SUBJECT: **NEW VEHICLE DEMONSTRATION / DELIVERY HOLD**
Compliance Recall 21C06 – Supplement #1
 Certain 2020 - 2021 Model Year F-150 and Super Duty Vehicles
 Windshield Glass Reattachment

REF: **Compliance Recall 21C06**
 Certain 2020 - 2021 Model Year F-150 and Super Duty Vehicles
 Dated: April 7, 2021

New! REASON FOR THIS SUPPLEMENT

FIGURE 1

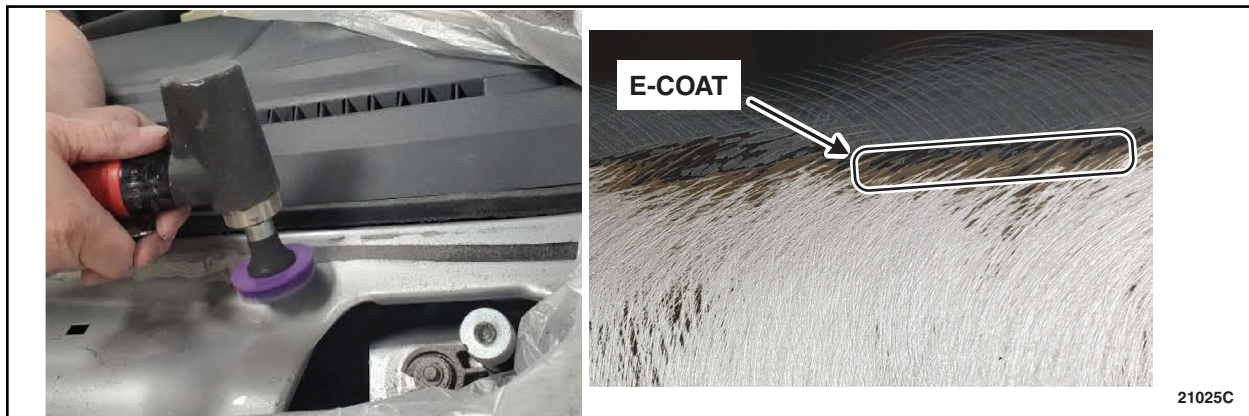
1. Cover/protect the body and interior of the vehicle.
2. Is the vehicle Lead Foot Gray?
Yes – Proceed to Step 3.
No – Proceed to Steps 4-6.
3. Using a Scotch-Brite 3M Roloc disk, remove all the urethane, clear coat, base coat, and paint primer only where the urethane will be applied around the entire *windshield body* flange perimeter. The goal is to expose the e-coat without going down to bare metal. See Figure 1.

FIGURE 17

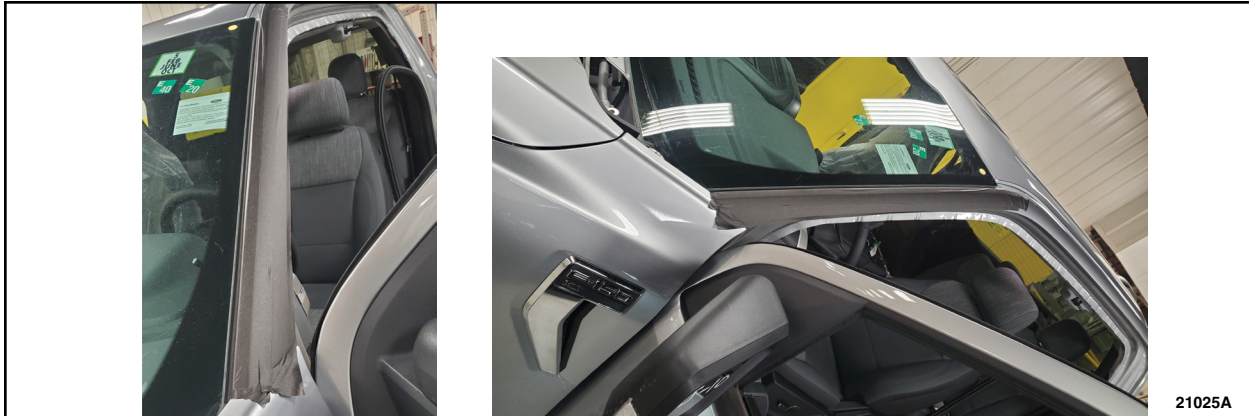
17. Apply tape to the perimeter of the windshield to protect from paint damage. See Figure 17.

NOTE: *Tape off the roof panel near the centerline of the vehicle, where the roof extends forward. When using a piano wire to cut out the glass, the wire will roll over the class A paint in the roof area, once tension is applied to it. If using a nylon style string, this will not damage the paint.*
